# UNITED STATES PATENT AND TRADEMARK OFFICE

APPLICATION NO.	FILING DATE	FIRST NAMED INVENTOR	ATTORNEY DOCKET NO.	CONFIRMATION NO.
10/088,114	07/18/2002	Hiroshi Inoue	NIP-275	8078

# Office Action Summary

**DETAILED ACTION**

**FIG. 1**

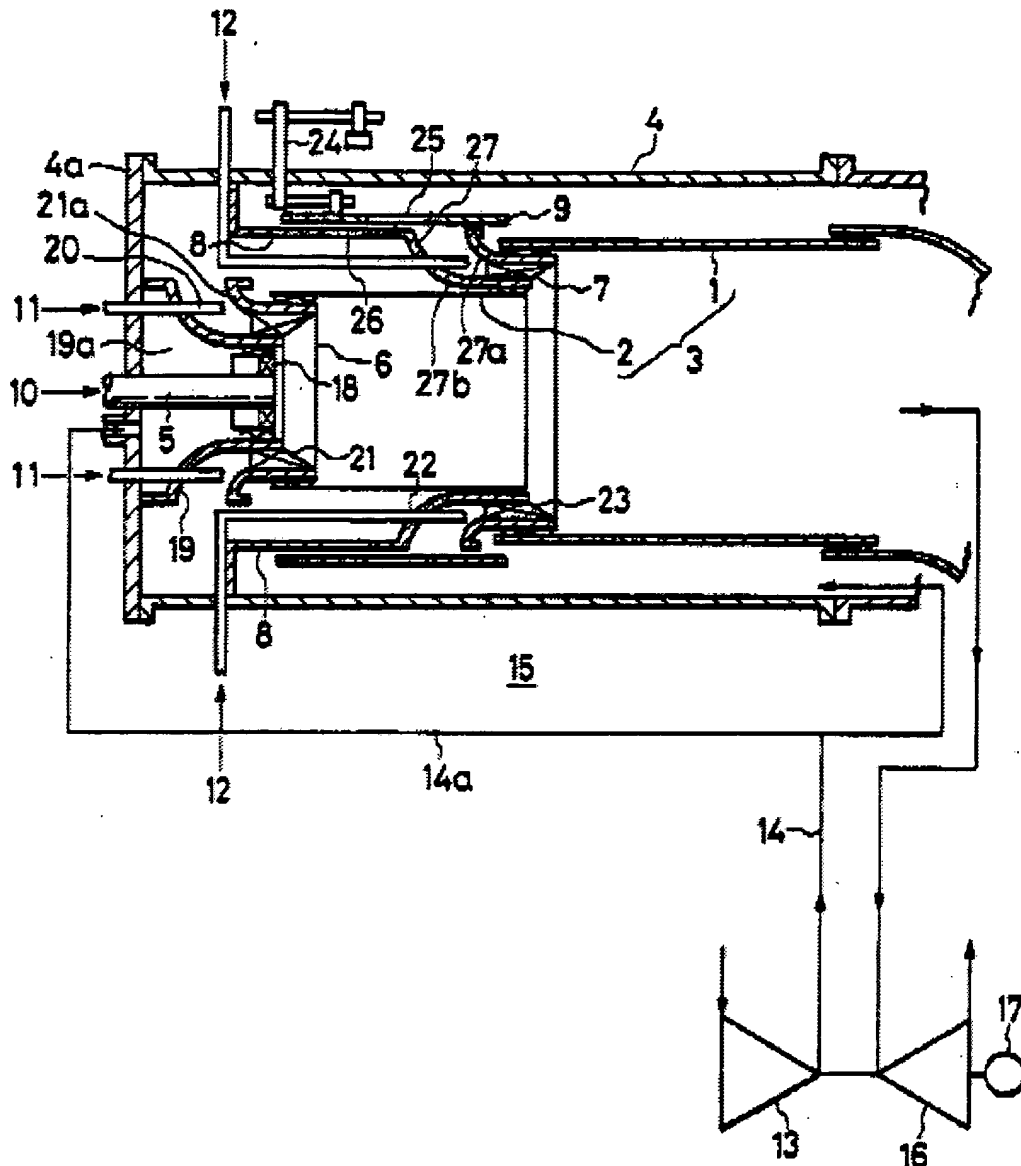
26. **Claims 1-3, 7, 9, 10 & 12-17** are rejected under 35 U.S.C. 102(b) as being anticipated by (5,069,029) to Kuroda et al.

Kuroda et al., Figure 1 as immediately displayed above discloses according to applicant's **claims 1-3, 7, 9, 10 & 12-17**, a gas turbine combustor (1) comprising diffusive combustion nozzles {inner ring of fuel fed nozzles (20)} which inject fuel and air into a combustion chamber (1) and form a diffusive combustion flame, outer and inner walls {framed by member (1), (2)-(9) & means for swirling (7)} which form an annular premixing flow passage {inline with (22)} and premixing nozzles (22) which are disposed in the premixing flow passage and form a premixing combustion flame by injecting premixed gas formed by premixing fuel and air into the combustion chamber (1) characterized in that a plurality of the premixing nozzles (22) are arranged in the premixing flow passage {inline with (22)} opening portions {between (2) & (27b), between (1) & (27b), between (8) & (9) and at (25)} permitting air to flow in are provided at the outer wall(s) {(9) and framed by (43)} so that the air flowed into the premixing flow passage forms swirling flow with respect to the premixing nozzles (22); and the opening portions {circumferentially framed volume sections between (27b) & (2), between (1) & (27b) and between (8) & (9) encompassing every two nozzles (22)} are disposed in circumferential

direction and are provided {at least} one for every adjacent two premixing nozzles (22) wherein the swirling flows at {(22) in (27b)} can rotate in directions opposite each other in the circumferential direction {especially during turbine gas flow transients like as during faulty starts or shutdowns} for every adjacent two premixing nozzles (22). See Kuroda et al., Figures 1 & 4 and respective portions, abstract, col. 3 lines 18-68, col. 4 lines 1-68 and col. 5 lines 1-9 of the detailed description.

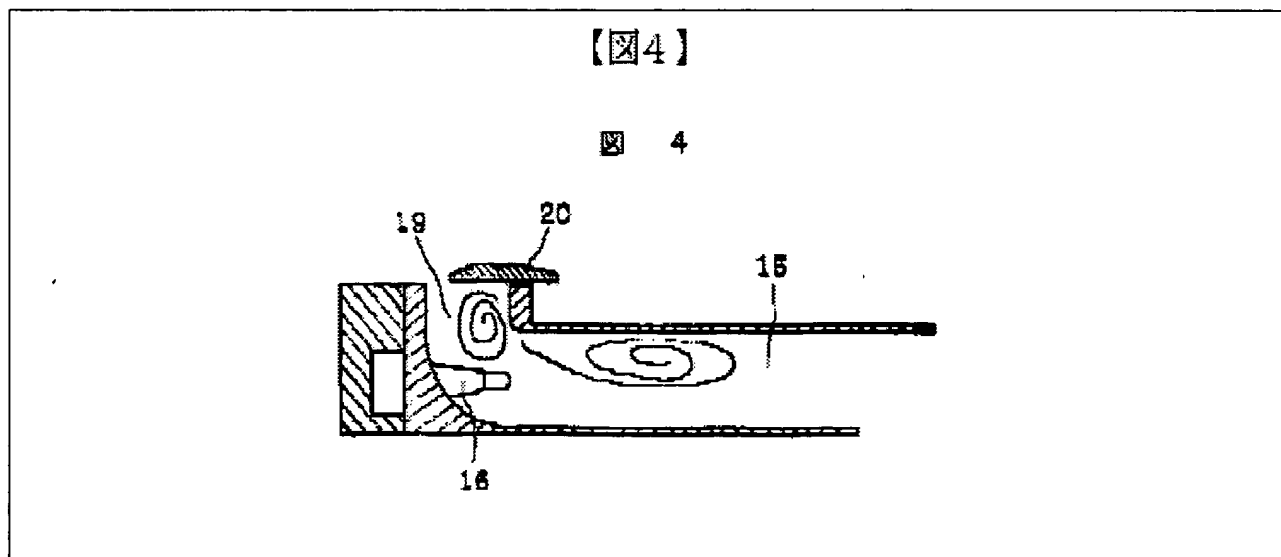
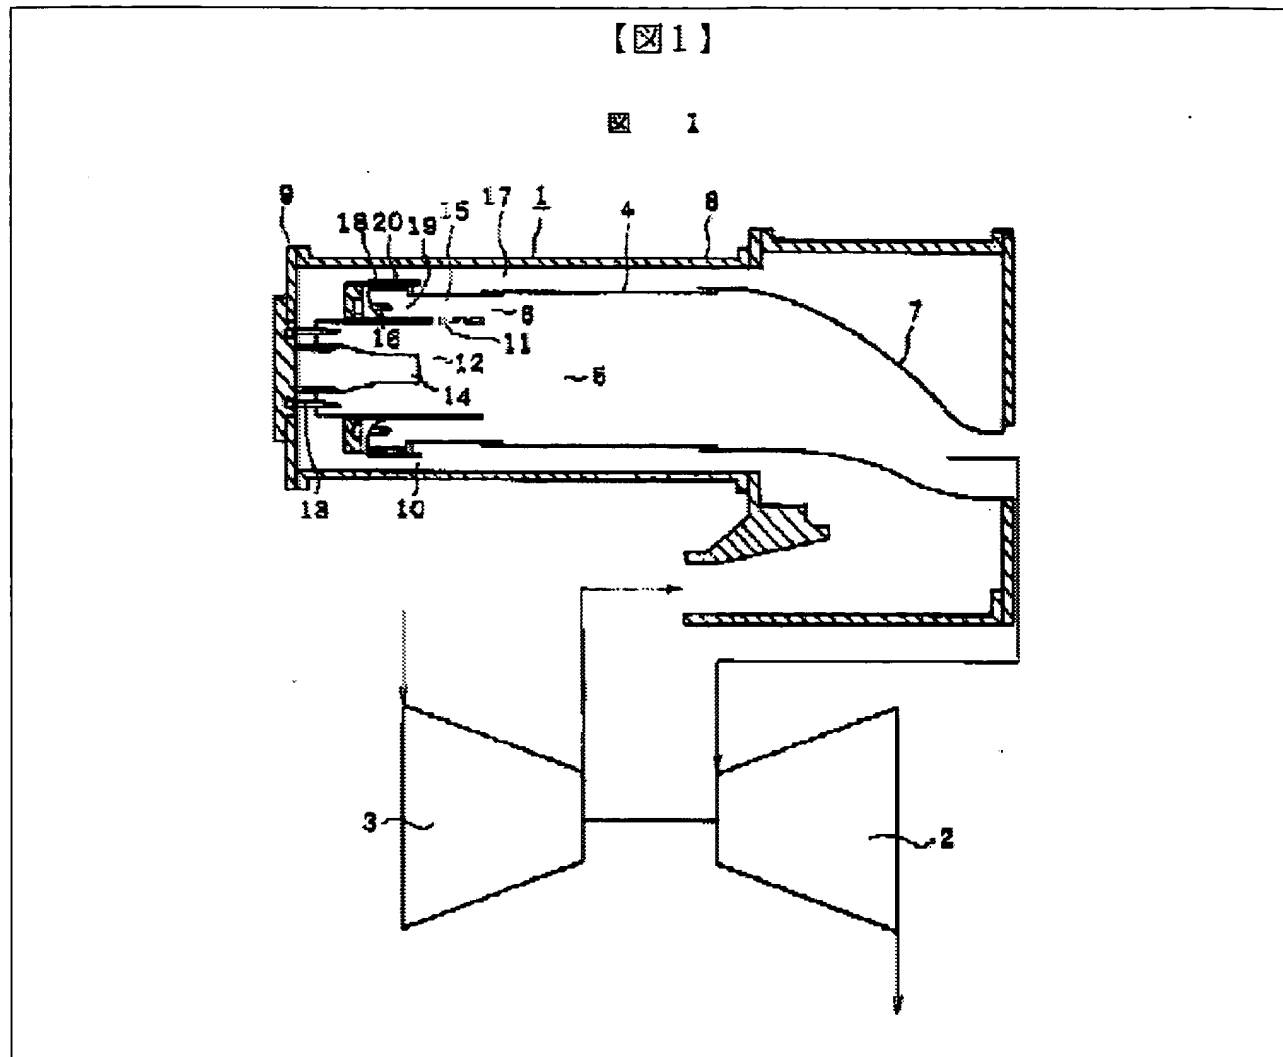
27. **Claims 1, 4 & 7** are rejected under 35 U.S.C. 102(b) as being anticipated by (JP-08135969) to Shohei et al.

Shohei et al., Figures 1 & 4 as immediately displayed above discloses according to applicant's **claims 1, 4 & 7**, a gas turbine combustor comprising diffusive combustion nozzles {See Fig. 1, inner ring of fuel fed nozzles (13)} which inject fuel and air into a combustion chamber (5) and form a diffusive combustion flame, outer {compound}{(15)-(20)} and inner

{part of (15)} walls which form an annular premixing flow passage (15) and premixing nozzles (16) which are disposed in the premixing flow passage and form a premixing combustion flame by injecting premixed gas formed by premixing fuel and air into the combustion chamber (5), characterized in that a plurality of the premixing nozzles (16) are arranged in the premixing flow passage (15); opening portions (19) permitting air to flow in are provided at the outer {compound} wall {(15)-(20)} so that the air flowed into the premixing flow passage forms swirling flow with respect to the premixing nozzles (16); and the opening portions (20){circumferentially framed volume sections encompassing opening (20) and every two nozzles (32)} are disposed in circumferential direction and are provided one for every adjacent two premixing nozzles (16). See Shohei et al. Figures 1 & 4 and English abstract.
